14 September 2026

Response to Further Advice Request and Notice of Minor Changes in relation to Development Application at Toowong Central (Council Ref.: A006836692)

2 Response to Further Advice

Figure 13 – Annotated Non-Residential Bin Collection

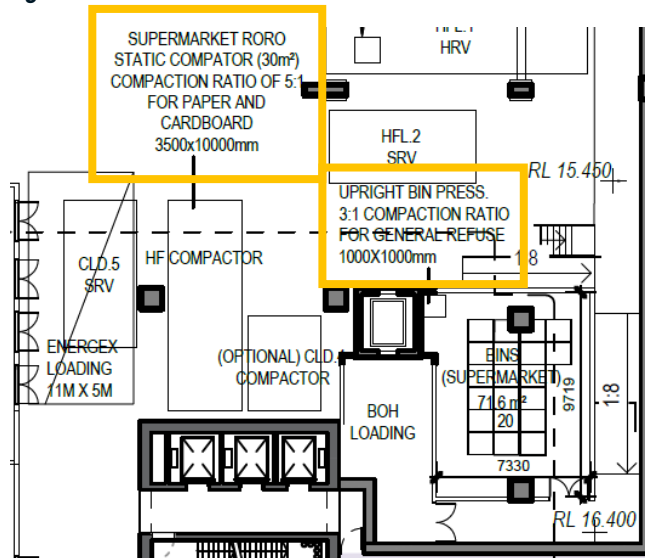
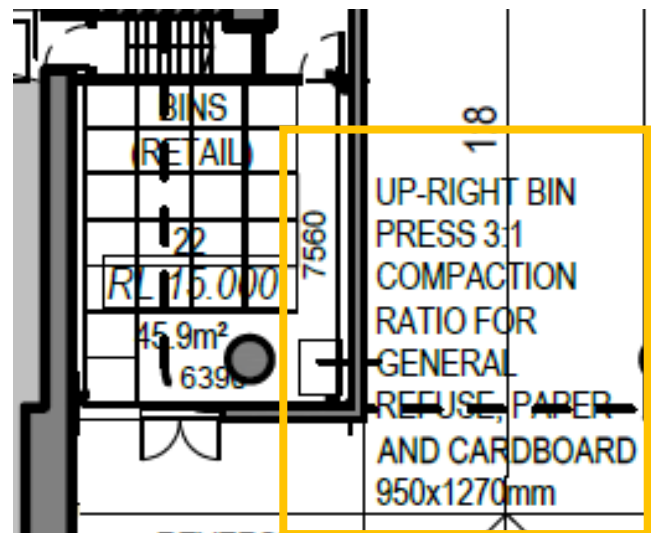
It is acknowledged that the ‘Supermarket uses’ have adopted reduction technology by means of an up-right bin press (3:1 compaction ratio) for general refuse and inclusion of ‘static compactor (30m²) with a 5:1 compaction ratio for cardboard’. Provide amended architectural plans addressing the following:

- a. Clearly demonstrate the storage location and include an annotation stipulating ‘up-right bin-press (3:1 Compaction ratio) for general refuse’ within the ‘Bins (Supermarket)’ bin room.*
- b. Demonstrate the size (length, width, height) of the ‘Supermarket RORO’ on a revised ‘Ground Site Plan’ and include an annotation which stipulates ‘Static Compactor compaction ratio of 5:1 for paper & cardboard’.*

In response to **Item 23** and **Item 24**, Colliers confirms that adequate storage is available for the upright bin press within the 'Bins (Retail)' room and the 'Bins (Supermarket)' rooms.

- The location of the upright bin press and its 3:1 compaction ratio for general refuse, paper and cardboard within the 'Bins (Retail)' area; and
- The location of the upright bin press within the 'Bins (Supermarket)' area, noting the 3:1 compaction ratio for general refuse; and
- The dimensions of the Supermarket RORO, identifying the static compactor and its 5:1 compaction ratio for paper and cardboard.
